## Error in drainage equation VIC?

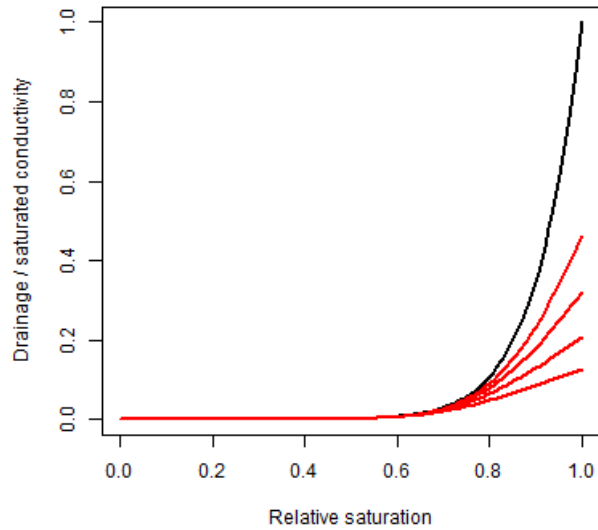
- 1) drainage does not become zero if water content equals residual water content, nor is drainage equal to  $K_s$  if water content equals saturated water content.

I then produced another graph, only changing  $K_s$  from 400 to 4 mm/d. The new graph is shown below

Now all four red lines almost coincide with the Brooks-Corey line, suggesting that 1) Eq.1 is a good approximation of Brooks-Corey for small values of  $K_s$  (e.g. 4 mm/d) and 2) I made no error in producing the graphs. However, values for mean  $K_s$  in Table 3 of Cosby et al. (1984) vary between roughly 100 and 4000 mm/d, so 4 mm/d is far below this range.

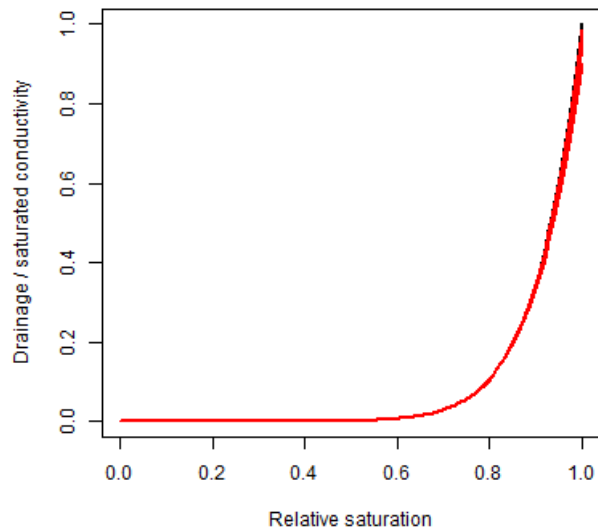
- 2) In the code units are in mm and mm per time step, i.e.  $\theta$ ,  $\theta_r$  and  $\theta_s$  are in mm (for the whole layer) and  $K_s$  and drainage are in mm per time step. The problem is that with these units Eq. 1 drainage is a function of layer depth since  $\theta$ ,  $\theta_r$  and  $\theta_s$  are proportional to layer depth. I demonstrate the effect of layer depth in the graph below, where I put Drainage /  $K_s$  on the vertical axis and relative saturation (the ratio of  $(\theta - \theta_r)$  and  $(\theta_s - \theta_r)$ ) on the horizontal axis. The black line corresponds to the Brooks-Corey equation. The red lines show Eq.1 for four layer depths (4000, 2000, 1000 and 500 mm from top to bottom). I set fractional (of the total volume)  $\theta_r = 0.1$ ,  $\theta_s = 0.45$ ,  $c = 10$ ,  $K_s = 400$  mm/d and used a time step of 1 day.
